SCOTTISH BORDERS COUNCIL

PART III REPORT (INCORPORATING REPORT OF HANDLING)

REF: 23/00844/FUL

DEVELOPMENT: Erection of dwellinghouse

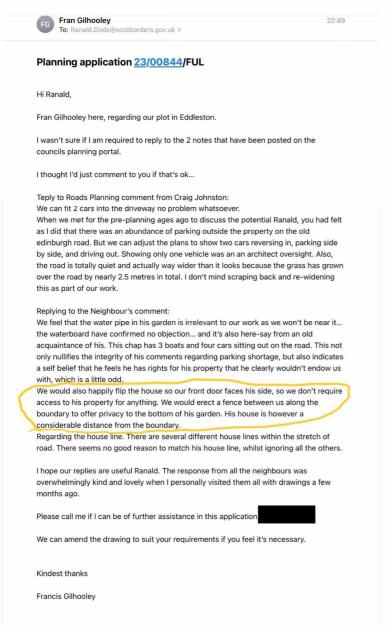
- The development would be contrary to policy EP13 of the Local Development Plan 2016 and NPF4 policy 6 together with Trees and Development guidance in that no account has been taken of the

tree within the site. No overriding case for the development as proposed has been substantiated. This conflict with the development plan is not overridden by other material considerations. If my emails had not been ignored by Ranald, these points would have been covered, but Ranald's lack of communication or response to my emails has made this application discussion impossible.
